**PLANNED UNIT DEVELOPMENT  
& SUBDIVISION STAFF REPORT****Date: March 2, 2006****DEVELOPMENT NAME**

Heron Lakes at Skyline

**SUBDIVISION NAME**Heron Lakes Subdivision, Phase One,  
Resubdivision of Lot 15**LOCATION**1232 Heron Lakes Circle  
(East side of Heron Lakes Circle, 240'± North of  
Yellow Heron Lane)**CITY COUNCIL  
DISTRICT**

# SITE PLAN

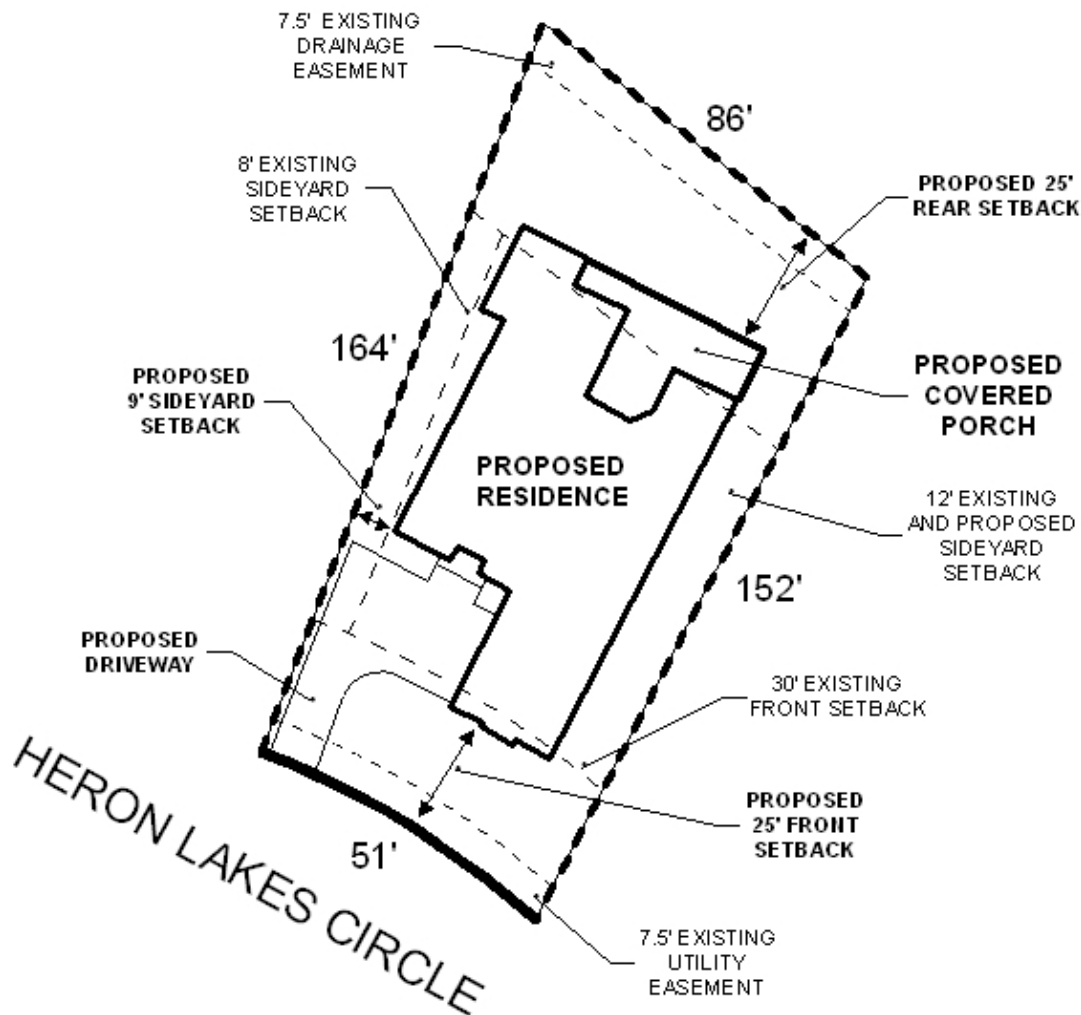
**ENGINEERING  
COMMENTS**Verification by an Engineer that the existing  
stormwater system, including designed and constructed detention, can accommodate the  
increased site coverage. Must comply with all stormwater and flood control ordinances.  
Any work performed in the right of way will require a right of way permit.**TRAFFIC ENGINEERING  
COMMENTS**Driveway number, sizes, location and design to be  
approved by Traffic Engineering and conform to AASHTO standards.**URBAN FORESTRY  
COMMENTS**Property to be developed in compliance with state  
and local laws that pertain to tree preservation and protection on both city and private  
properties (State Act 61-929 and City Code Chapters 57 and 64).**FIRE DEPARTMENT  
COMMENTS**All portions of any new structures built or moved  
onto the property would have to be within 400 ft. of at least one Fire Hydrant, possibly

The applicant is requesting to increase the maximum allowable site coverage; the Ordinance allows 35% site coverage in an R-1, Single-Family Residential district, the applicant is requesting 37 percent. In single-family residential PUDs, and in Heron Lakes in particular, additional site coverage is frequently requested; and in this instance the request is minimal – 2 percent. However, a typical condition is the submission of verification by an Engineer that the existing stormwater system, including designed and constructed detention, can accommodate the increased site coverage.

The proposed setback lines (25-feet on the front and rear) comply with the minimum setback requirements of both the Zoning Ordinance and Subdivision Regulations and thus could be considered appropriate for the site.

**Planned Unit Development:** Based upon the preceding, this application is recommended for approval subject to the following condition: 1) that the Engineer provide verification that the existing stormwater system, including designed and constructed detention, can accommodate the increased site coverage.

**Subdivision:** The plat meets the minimum requirements of the Subdivision Regulations and is recommended for Tentative Approval subject to the following condition: 1) that the Engineer provide verification that the existing stormwater system, including designed and constructed detention, can accommodate the increased site coverage.
